**Historical Architectural Review Board
COA Final Review Sheet**

HDC-2023-00014

Address: 519 W. Liberty Street

Proposal: Reconstruct front porch

**Drawing of porch reconstruction.
(Applicant)**

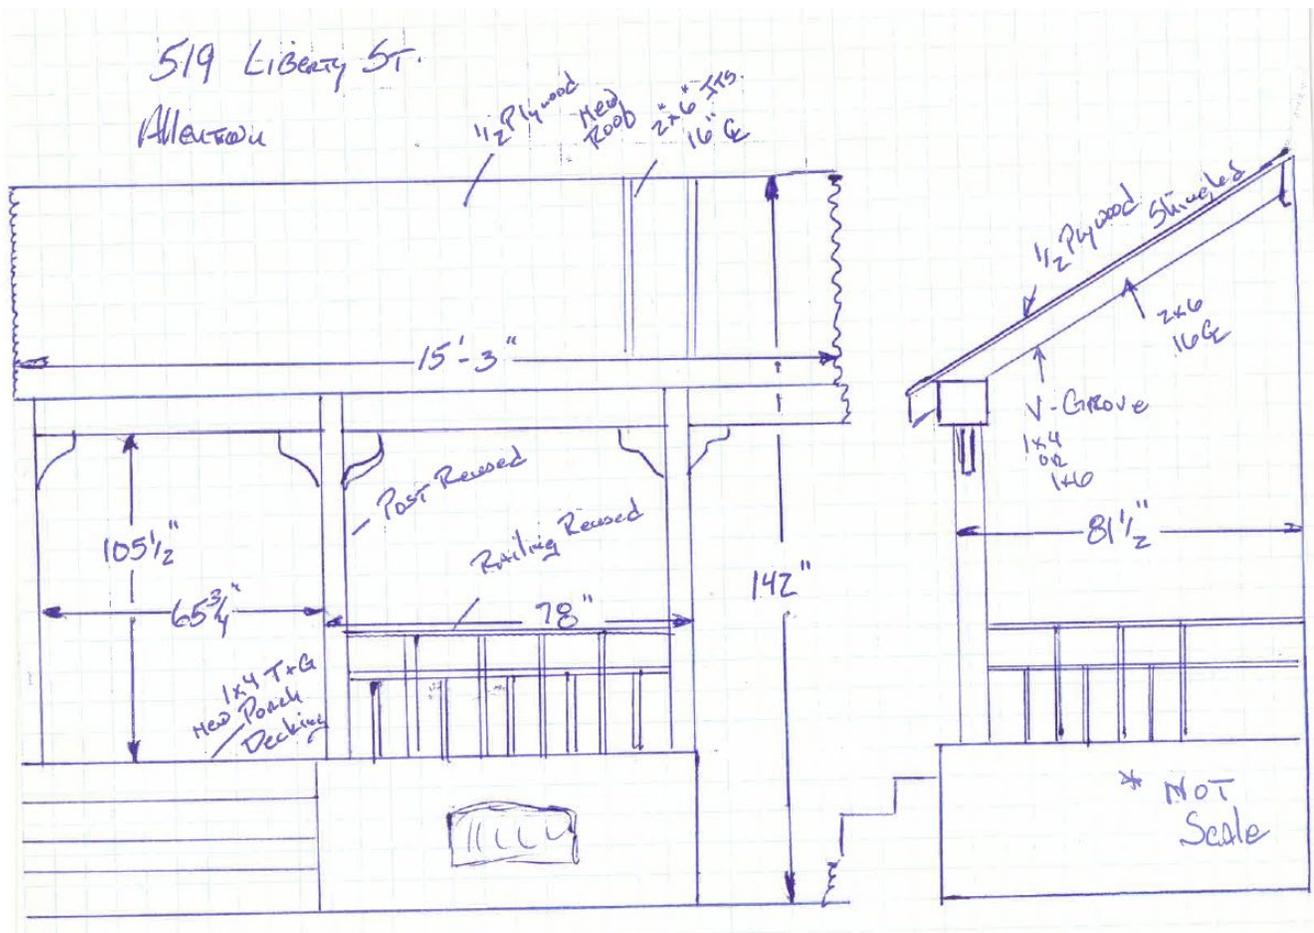
The applicant contends that the porch roof is in poor condition and requires replacement, and the floorboards show visible signs of warping, displacement, and deterioration. The design guidelines recommend replacing features with new materials matching in composition, size, shape, profile, dimension, appearance, and finish. The application proposes to rebuild the roof to the same appearance and replace the decking with new tongue and groove floorboards. Because the applicant also proposes to salvage and reinstall the historic posts, brackets, and railings, the application complies with most guidelines in Chapter 3, Section 3.7 Porches & Steps. In order to better comply with the guidelines, staff recommends using a roofing shingle that more closely replicates the dimension, size, shape, and color of the historic slate roofs of the row; however, staff notes that no porch roof retains the original slate, so some flexibility should be granted. Staff also recommends avoiding wrapping the header fascia with aluminum, which would not comply with the guidelines. While the proposed vinyl vented ceiling does not comply with the material recommendations of the guidelines, staff contends that if the material is installed behind the porch header, it will have minimal visibility from the street and may be considered, since it will have low overall impact on the façade.

- the asphalt shingles on the new porch roof match the general dimension, size, shape, and color of the historic slate roofs of the row;
 - the proposed vinyl ceiling is limited to the area behind the porch header and is minimally visible from the street; and
 - the fascia is not wrapped in aluminum.
-

Mr. Overdorf explained that the porch structure is entirely rotted and needs to be removed and rebuilt. He clarified that he could use beadboard at the ceiling of the roof where he initially proposed the vinyl soffit, though he noted the owner requested vinyl for maintenance reasons. The existing porch posts and railings, he continued, would be scraped and painted, and he would install tongue-and-groove wood flooring. He noted the flooring would be a close, but not exact, match.

Mr. Huber asked whether the applicant would install beaded tongue-and-groove wood at the ceiling. Mr. Overdorf affirmed he would use the wood tongue-and-groove beadboard, which would be installed over the rafters. The HARB and applicant discussed the finishing of the rafter tails and the dimension of the overhang, which would be replicated.

Mr. Jordan asked about the roof shingles. Mr. Overdorf responded that he could use 3-tab shingles rather than architectural shingles to better replicate the shape and dimension of slate. He added that the gutters would be replaced. Mr. Huber requested half-round gutters, and Mr. Overdorf agreed.

- the fascia is wood;

- the ceiling is wood beadboard rather than vinyl;
- half-round gutters are installed; and
- the asphalt shingles on the new porch roof match the general dimension, size, shape, and color of the historic slate roofs of the row.
